6.2 Ministerial Planning Referral TPMR-2019-20, 600 Lonsdale Street, Melbourne

TPMR-2019-20 - FMC SUBMISSION TO AGENDA ITEM 6.2 600 LONSDALE STREET, MELBOURNE

Figure 1 – Comparison of originally lodged vs currently amended street wall articulation

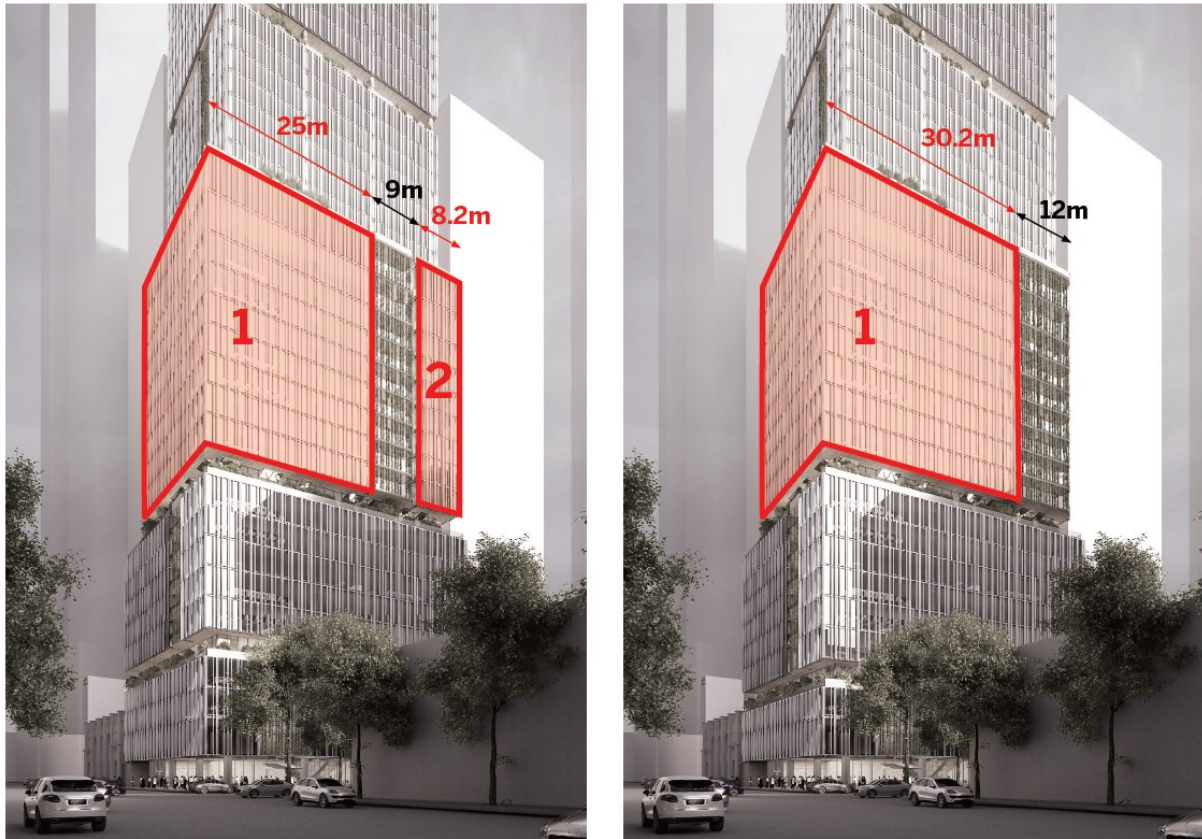
We note that the applicant has responded to previous feedback from both City of Melbourne and the Department regarding the street wall length by increasing the landscaped reveal on King Street to 12 metres and shifting this reveal to the north end of the frontage. This creates a defined 30.2-metre-wide volume at the corner of King and Lonsdale Street (please see Figure 2 overleaf).

We contend that the proposed street wall articulation appropriately responds to the built form outcomes of Design and Development Overlay 10 (DDO10), including providing better internal and external amenity. Specifically, the proposed street wall length:

- Responds to the prominence of King Street.
- Provides a clearly defined corner volume of vertical character.
- Creates additional separation at the sensitive residential interface to the west by allowing floor area to be redistributed (please see Figure 3 overleaf).
- Maintains continuous and legible landscaped amenity spaces, reinforcing the articulation strategy.
- Provides a commercially viable and attractive office floor plate (discussed further in Section 1.3).

Figure 2 – Proposed street wall vs 25 metre street wall

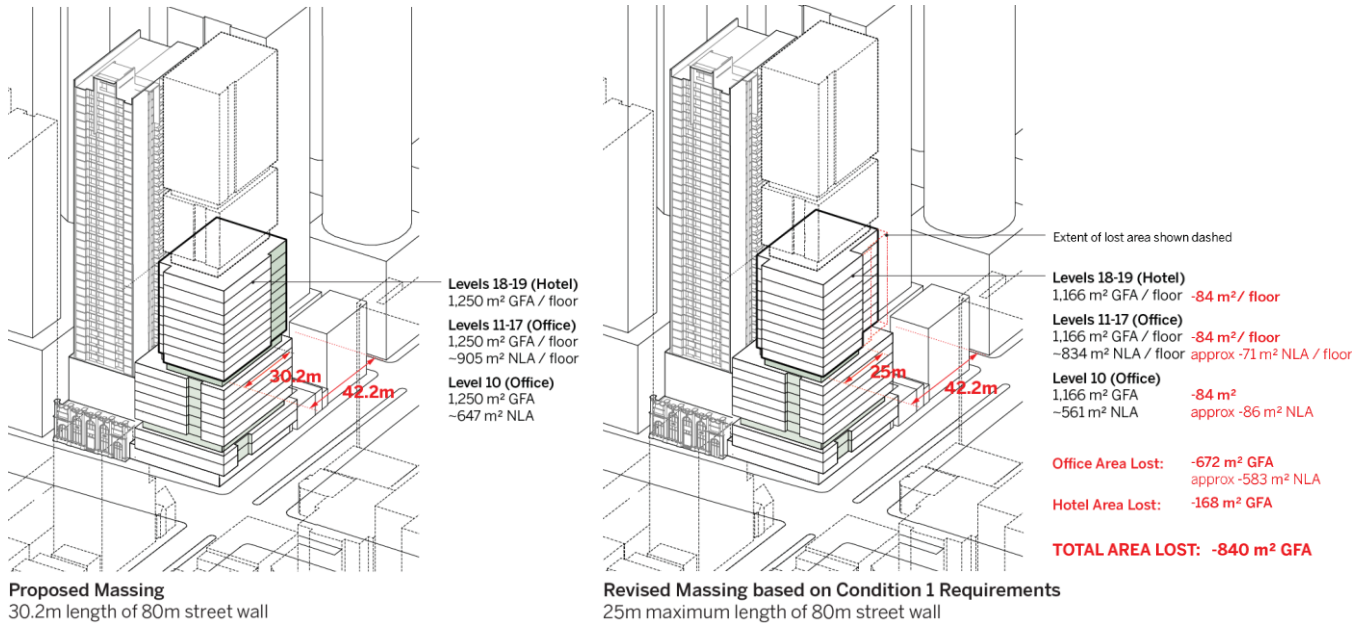
Council's officer assessment provides an approximate total floor area reduction of 650 square metres, based on the implementation of the recommended street wall length of 25 metres. On the assumption that this is Gross Floor Area (GFA), we note that this does not account for balconies which, if covered, should be included in GFA calculations (based on the definition of GFA within the Planning Scheme).

Council's floor area loss calculation also does not account for resultant floor area lost to Level 10.

Based on the above inclusions, a reduced 25 metre street wall would create a total GFA loss of 840 square metres. This comprises 672 square metres of office GFA and 168 square metres of Hotel GFA. The impact per level is shown in Figure 1 overleaf.

The Officer Report notes that *'the only option for the proposal to regain the loss in floor area would be to add an additional level to the tower element of the proposal whilst also providing compliant setbacks.'* It is important to understand that the increased setbacks required from this additional height further reduce the floor area that can be achieved at each level above 80 metres and prevent the ability to regain the area lost in full. Furthermore, the floor area added would be hotel use, rather than office.

Figure 3 – Redistributed floor area

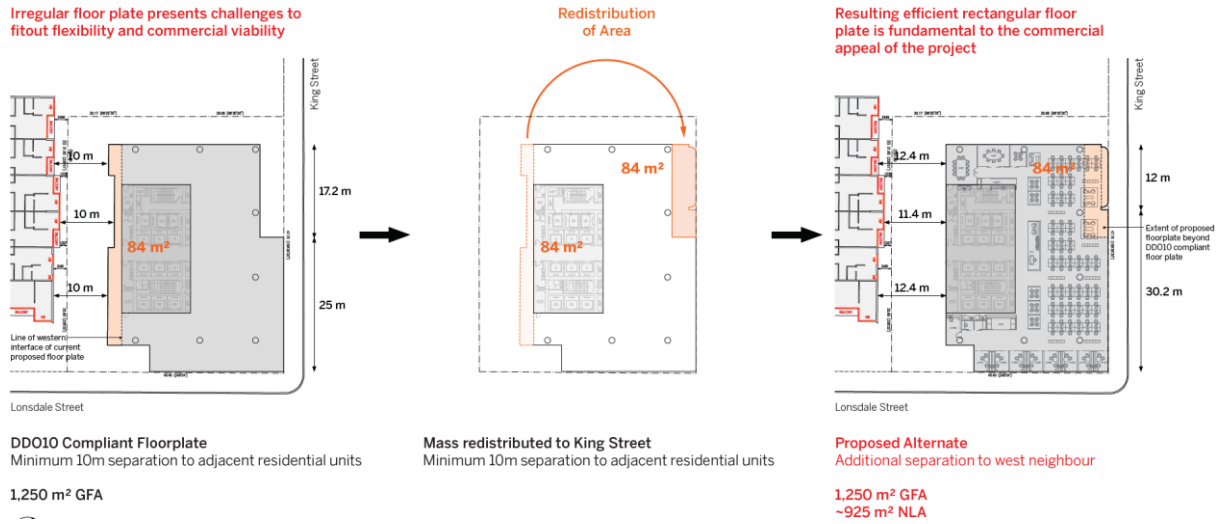
The redistribution of the floor area from the west to the east (King St) was driven by the obvious need to be an ‘equitable neighbour’, driven by the insufficient tower setbacks permitted to the residential building to the west (Melbourne One Apartments at no. 618 Lonsdale Street).

As demonstrated by Figure 3 above, the redistribution of the floorplate not only results in the ability to provide a commercially viable floorplate, it provides much needed additional relief by way of setbacks to the west. A DDO10 compliant floorplate would result in a poorer outcome for the existing residents of the neighbouring residential building. A balance has been struck in this instance to provide an appropriate outcome for both sites.
